Access Compliance Report

Public Rights-of-Way

(Pedestrian Signals)

Intersection ID: N/A	Main Street:	Cross Street: N/A	Location: N/A
ADA ID: 6F0B9B19251E	Signal Type: One Push Button-Non APS	Overall Compliance: No	Severity Score: BTN 1: N/A BTN 2: N/A No BTN: N/A
Codes/Mitigation Info/Possible Solution		Field Measurements/Component Compliance

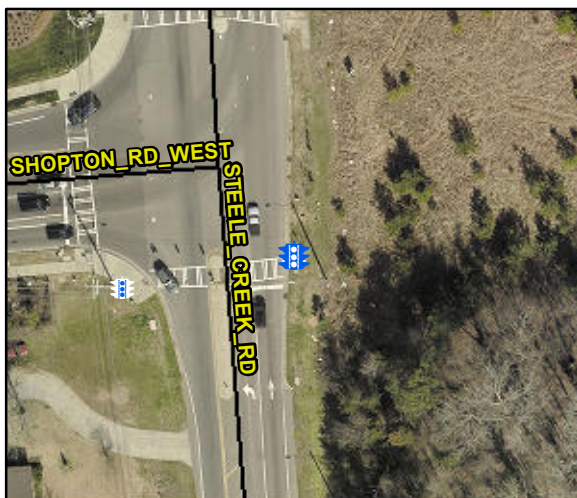
PROW/ADA: R209.1, TMUTCD 4e.08, R404.3, R404.1, R404.7.1, R404.7.2

Yes	B 1 Clear Xing Direction?	ClearlyMarked	N/A	B 2 Clear Xing Direction?	N/A
	B 1 Crossing Direction	To W		B 2 Crossing Direction	N/A
Yes	B 1 DistanceTo XWalk (in)	31.0	N/A	B 2 DistanceTo XWalk (in)	N/A
No	B 1 DistanceTo Curb (in)	98.0	N/A	B 2 DistanceTo Curb (in)	N/A
Yes	B 1 Diameter (in)	2.0	N/A	B 2 Diameter (in)	N/A

Possible Solutions: Replace Signal Push Button With APS Button on New Post. Remove & Relocate Sign.
